TECHNICAL MEMORANDUM

TO: Robin Johnstone **DATE:** January 21, 2003
 De Beers Canada Mining

RE: **SNAP LAKE TECHNICAL SESSION FOLLOW-UP
 RESPONSE TO CHRIS BURN'S QUESTION**

Figure II.17

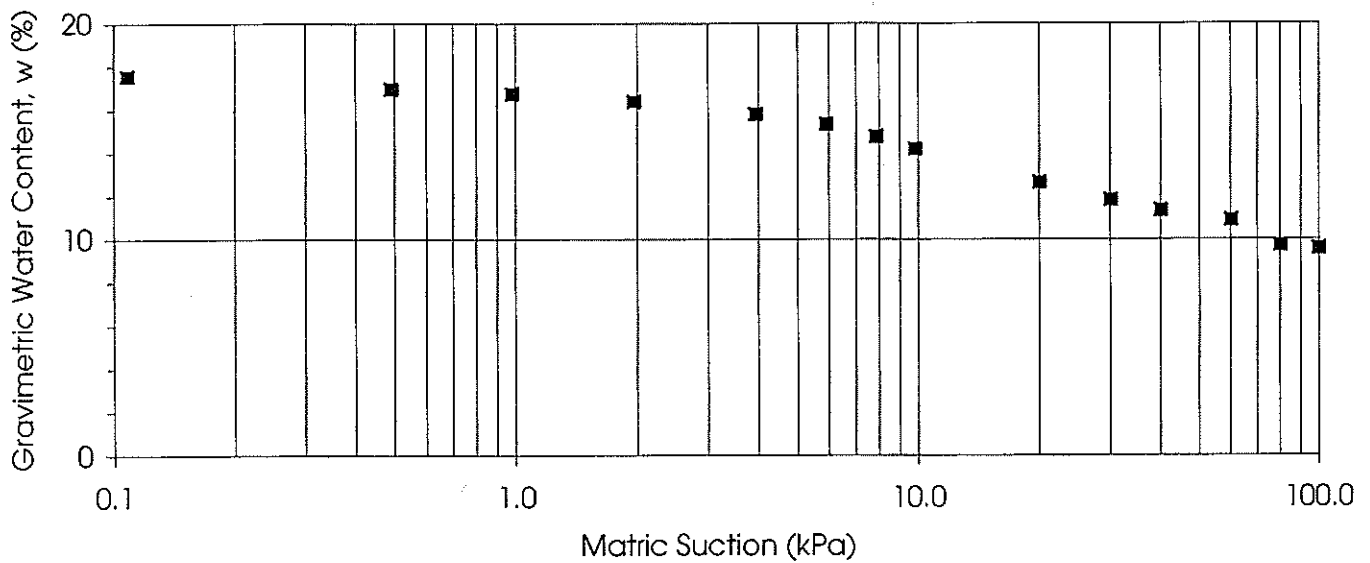
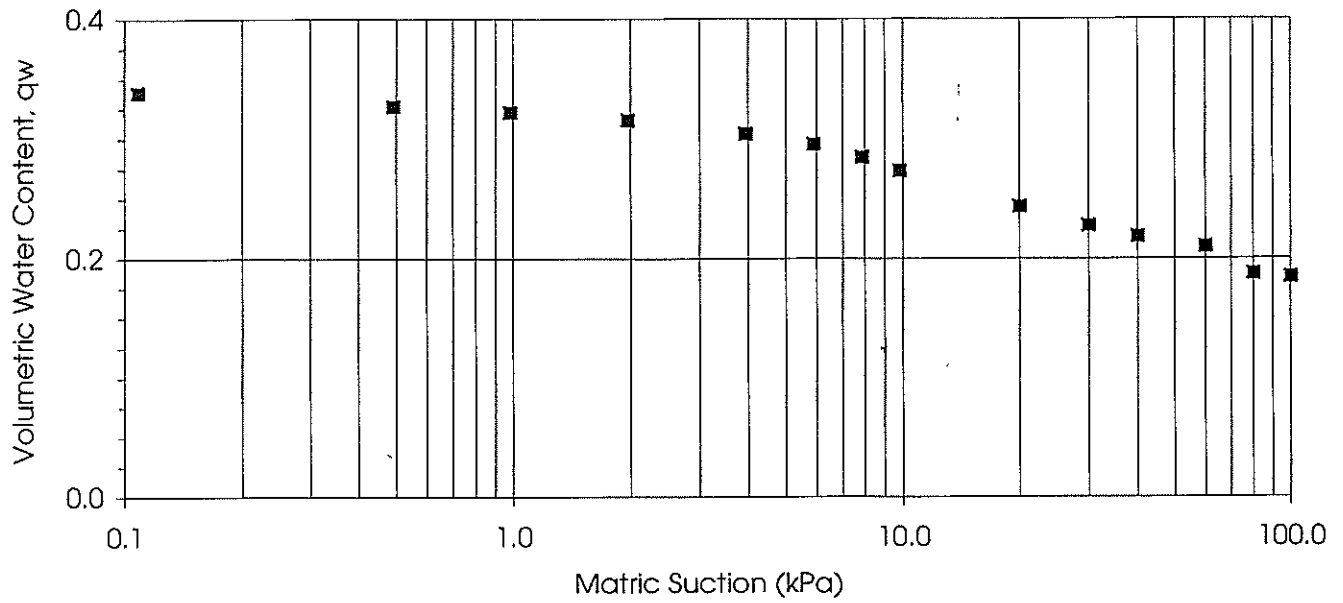
"What will be the water content of the paste PK in the North Pile after it becomes free-draining?"

Laboratory testing was carried out by Advanced Field and Lab Testing of Saskatoon, Saskatchewan to determine the soil-water characteristic curve of the paste PK. The result of this laboratory testing was provided in the report titled "Snap Lake Diamond Project, Surface Engineering, Optimization Study, North Pile Management" submitted by Golder Associates to AMEC. The results of the laboratory testing were provided on Figure II.17. A copy of this information is provided with this memorandum.

The results of this laboratory testing indicate that the paste PK will drain to a water content in the range of 9 to 10% (weight water/weight solids).
